FINAL DRAINAGE REPORT

DEYOUNG SUBDIVISION
BENT GRASS MEADOWS DRIVE

Engineering Review

PCD-ENGINEERING REVIEW COMMENTS
IN BLUE BOXES WITH BLUE TEXT

FIGURE 5-7. RIPRAP EROSION PROTECTION AT CIRCULAR CONDUIT OUTLET.

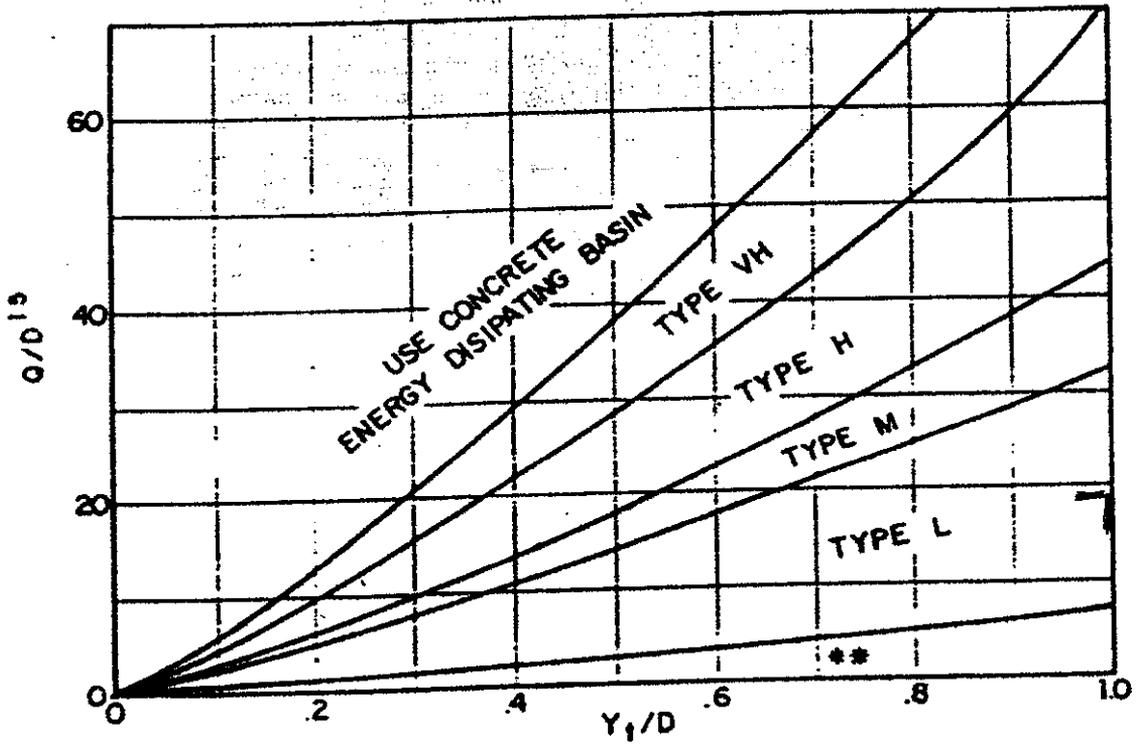
this should be closer to the calculated flow; verify watershed information input

PHASE 1 DEVELOPED DRAINAGE PLAN

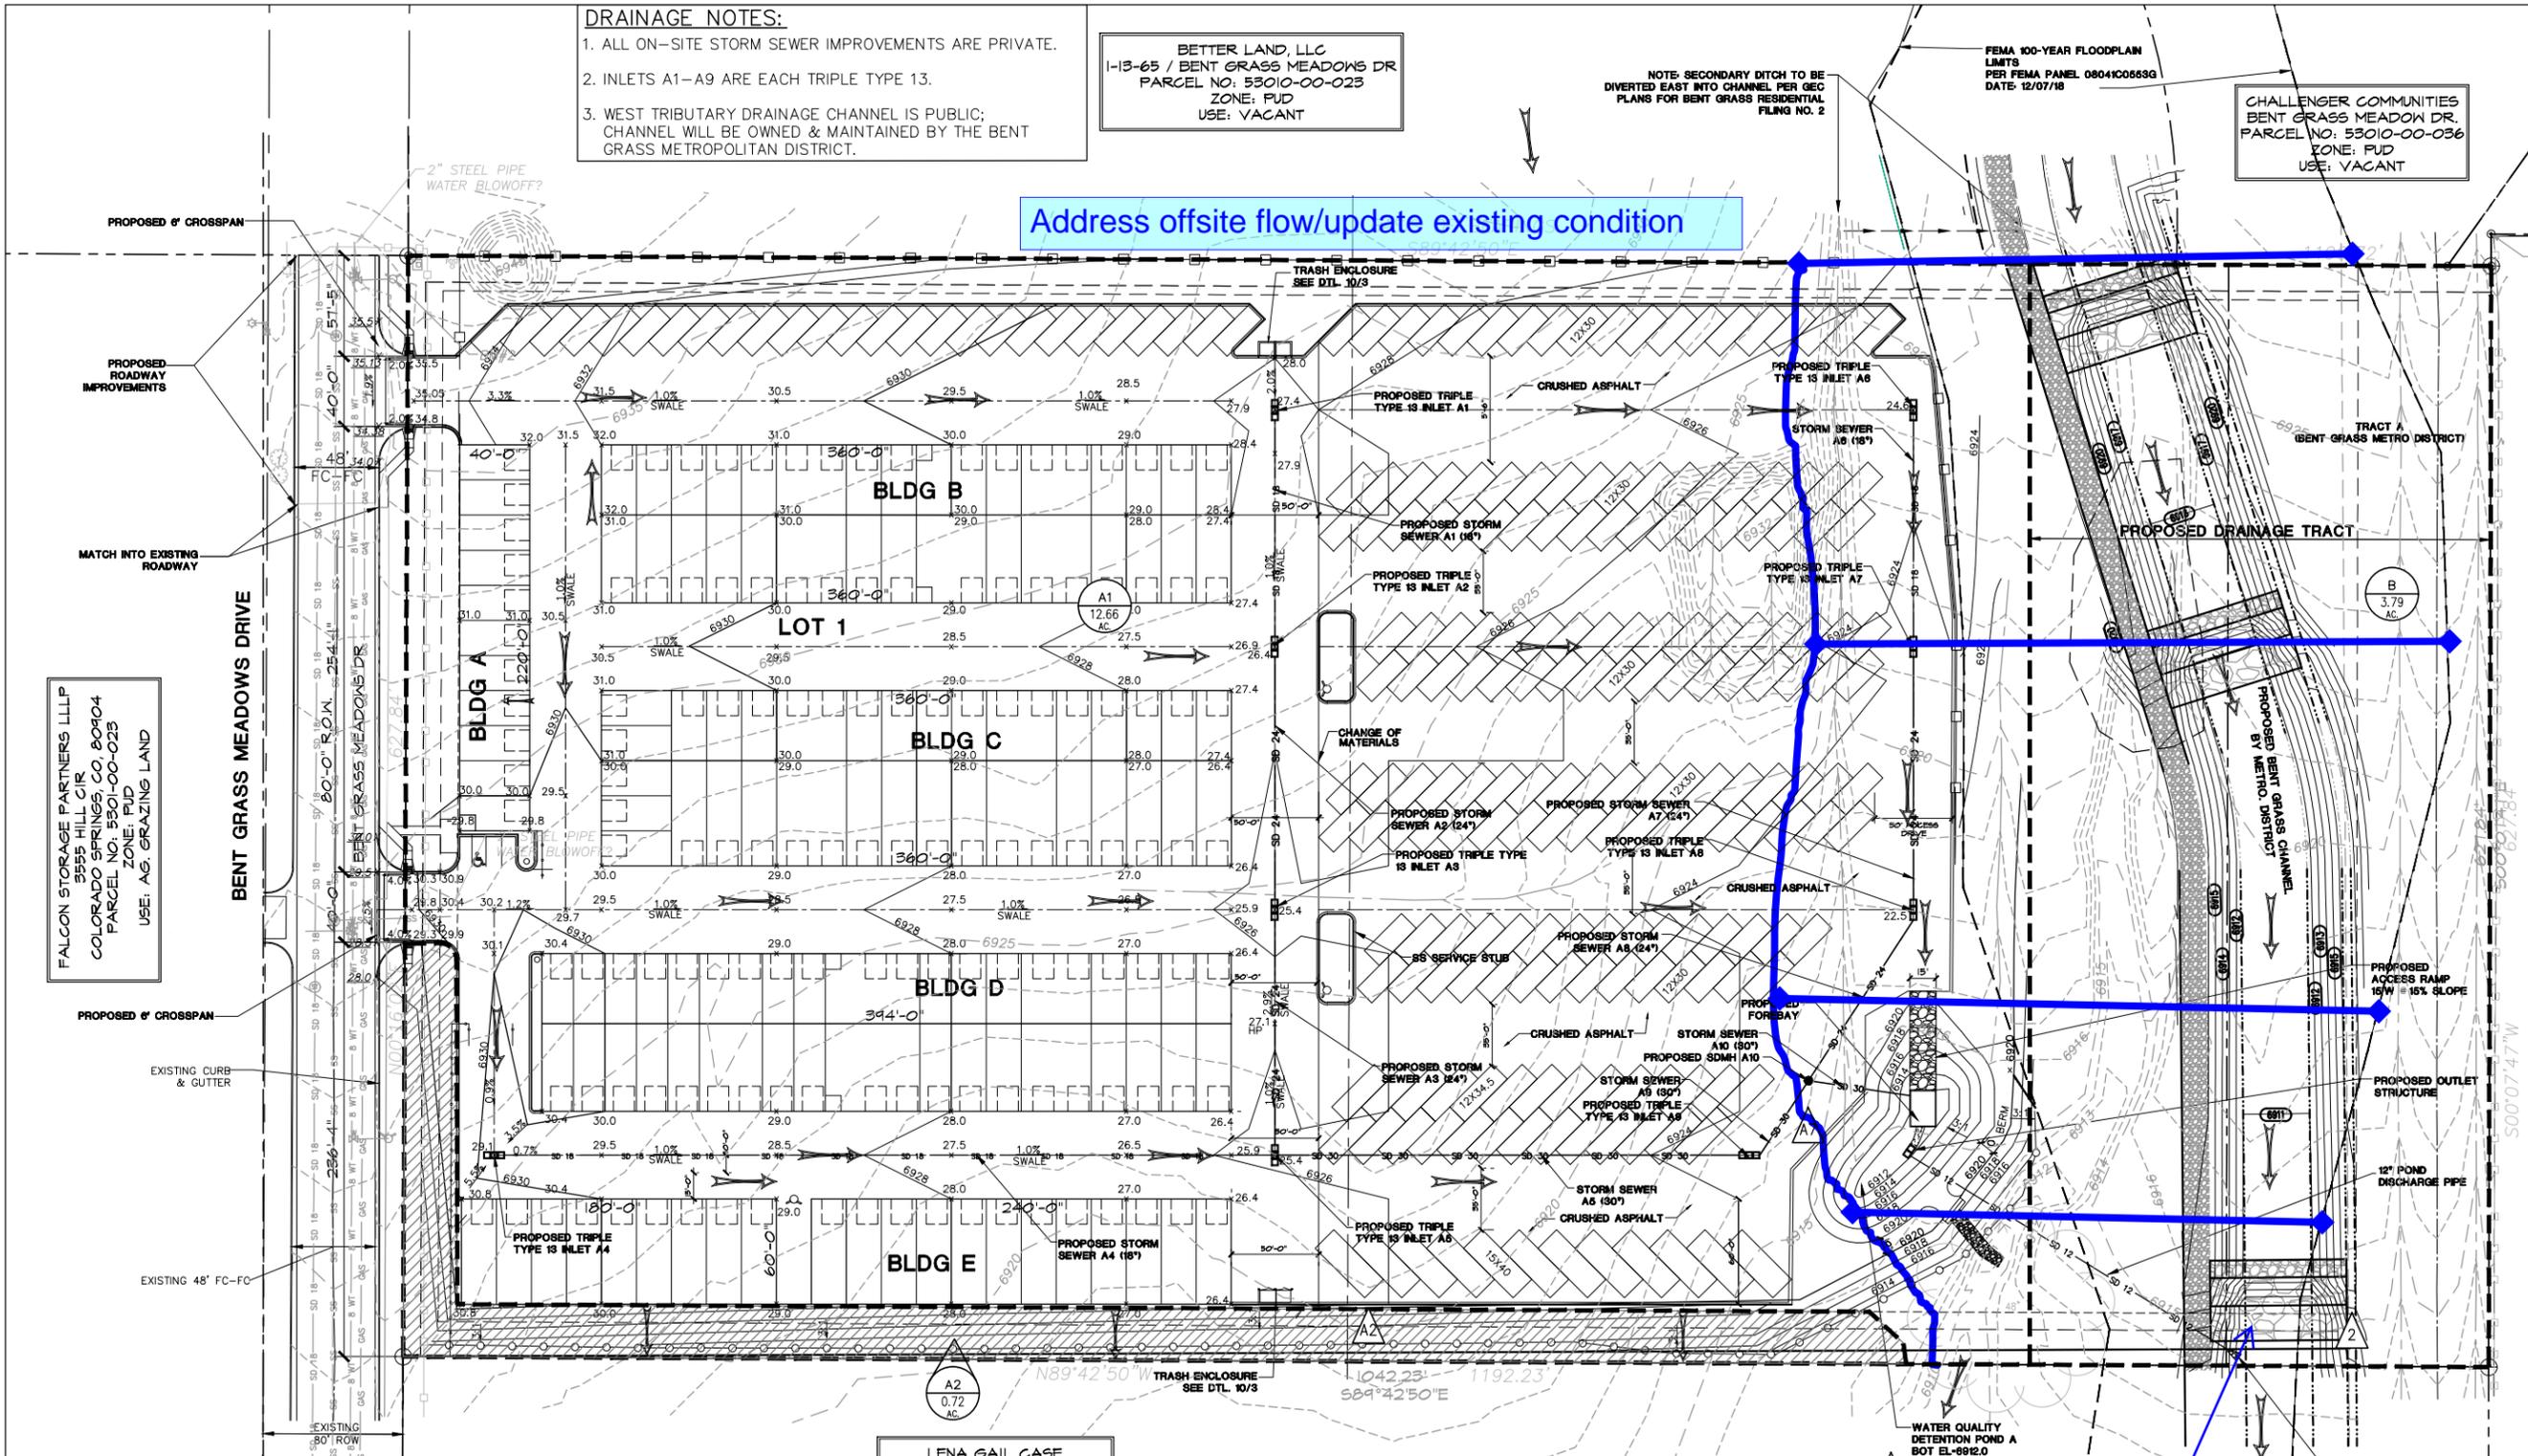
Address offsite flow/update existing condition

If phase 1 is before the channel is constructed, don't show the channel and adjust pond outfall pipe
